Technical Note

Project:	Land North of Thompsons Farm (OUT/2019/0484)		
Subject:	Surface Water Outfalls		
Author:	Atkins		
Date:	07/05/2019	Project No.:	5155372
Distribution:	Representing:

Figure 1 - Outfall 1 downstream arrangement

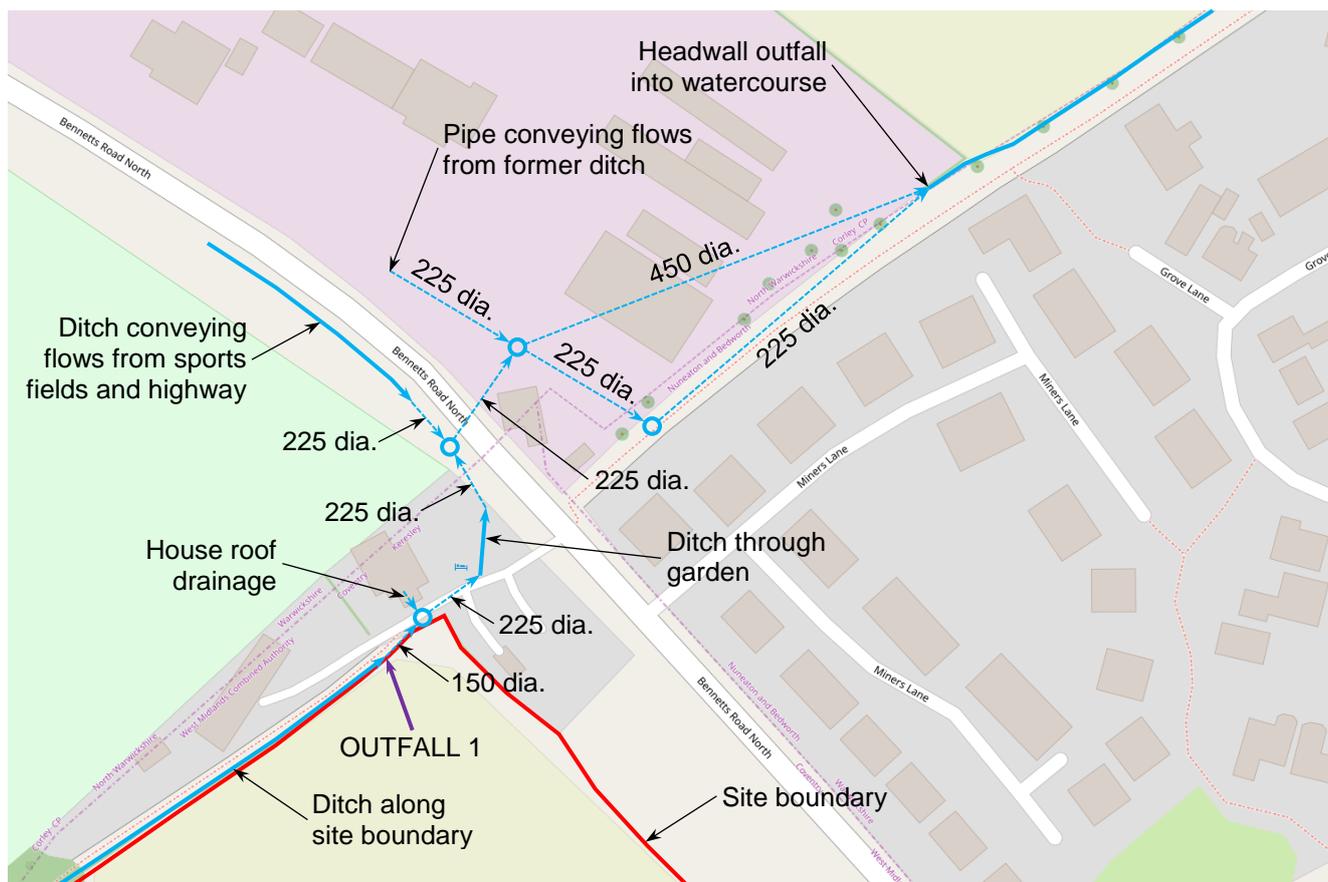
Outfall 1 is located in the northern corner of the Site and comprises a watercourse running along the northern boundary of the Site before entering a 150mm diameter culvert. The LLFA has raised the following concerns regarding this outfall:

The watercourse at the North West boundary of the site is not recorded in mapping or evident on a site visit. No details have been provided of culvert or other private drainage between the proposed outfall and a known watercourse which issues at XY point 431456 285342. The applicant will need to demonstrate how an appropriate connection can be made from the site to the known watercourse or other suitable eventual outfall; permissions from landowners will be required. If a new outfall or alterations to an existing outfall are required at XY point 431456 285342, consent will be required from Warwickshire LLFA at some stage.

The topographical survey of the Site and its immediate surroundings shows that the watercourse along the northern boundary becomes progressively less defined with distance downstream towards Bennetts Road North. Towards the northern corner of the Site, the watercourse becomes a shallow channel coincident with a public footpath also running along the boundary. At the downstream end of the watercourse, immediately adjacent to the northern corner of the Site, there is a 150mm diameter pipe which conveys water away from this area. The Proposed Development will discharge surface water to the upstream end of this pipe.

Site inspections have confirmed the presence of the 150mm diameter pipe and have determined the configuration of the pipework further downstream between the Site and a watercourse on the north-eastern side of Bennetts Road North. This is illustrated in Figure 1.

This shows that there is a continuous flow path from the Site to the watercourse further to the north-east. An internal inspection will need to be undertaken later in the development design process to confirm the condition of these pipes. If this identifies a requirement to upgrade any of the pipework, there are areas of highway land through which alternative drainage routes could be run. It should be noted that discussions with local residents have established that they would welcome any works to upgrade the drainage provision in this area.

Figure 2 - Outfall 3 downstream arrangement

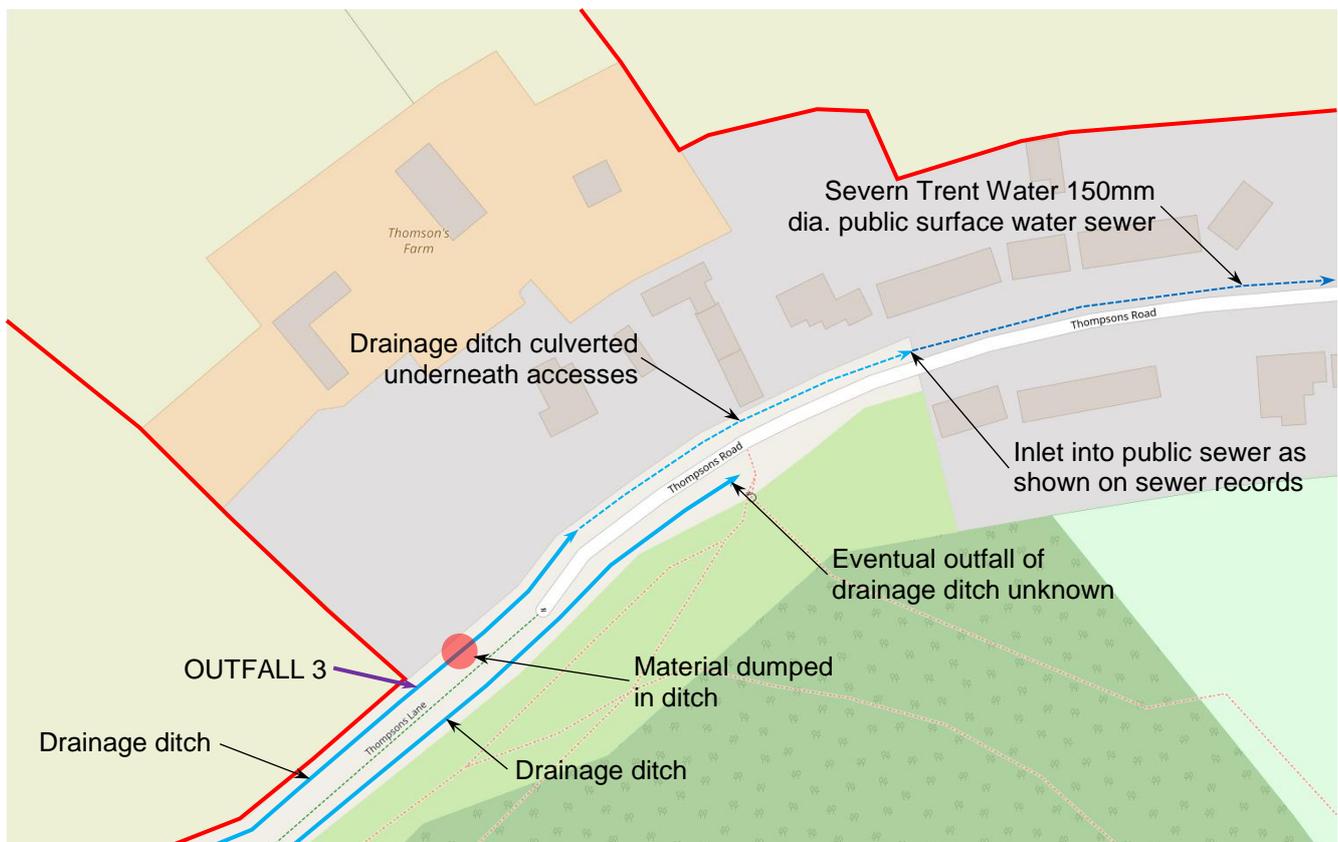
Outfall 3 serves the southern section of the Site to the west of Thompsons Farm. The outfall is located in the most easterly corner of this part of the Site and comprises a ditch running in a generally easterly direction along Thompsons Road. The flows in this ditch ultimately discharge into the public surface water drainage system. The LLFA has raised the following concerns regarding the use of this outfall:

The watercourse is a ditch between the boundary of the site and a private road. An outfall will require land drainage consent from Coventry LLFA (ourselves). The ditch is likely to connect to private drainage, then a 150mm public surface water sewer; there may be capacity / permission issues with both, and therefore potentially new or upgraded infrastructure required.

A site inspection has been undertaken to establish the drainage arrangement immediately downstream of Outfall 3. The results are illustrated in Figure 2. This has shown that there are a number of differences between what is currently shown on Severn Trent Water sewer records and the physical arrangement on site.

A search on the Land Registry has shown that the land through which the drainage ditch and its culverted section immediately upstream of the public surface water sewer runs within either highway or unregistered land. An internal inspection of downstream pipework will need to be undertaken later in the development design process to confirm its condition. If any works need to be undertaken to upgrade the downstream drainage, this can be undertaken in land outside of private ownership. As a minimum, the material that has been dumped in the ditch immediately downstream of the proposed outfall location will need to be removed.

The Proposed Development will provide additional control to the flows that enter the drainage ditch. At present there is no limitation to the flow rates that can leave the Site and enter the ditch. Post-development, the flow rates will be controlled to a maximum of the existing annual average rate less 20% for all events up to and including the 1 in 100-year +40% (climate change) rainfall event. This reduction in flows will improve the resilience of the system downstream to manage more extreme rainfall events.

Severn Trent will assess the implications of the proposed flow rates entering their system once planning consent has been granted. At this stage they will advise whether they need to undertake any downstream upgrade works to accommodate these. The cost of these upgrade works will be covered by the Infrastructure Charge that is payable by all new developments.
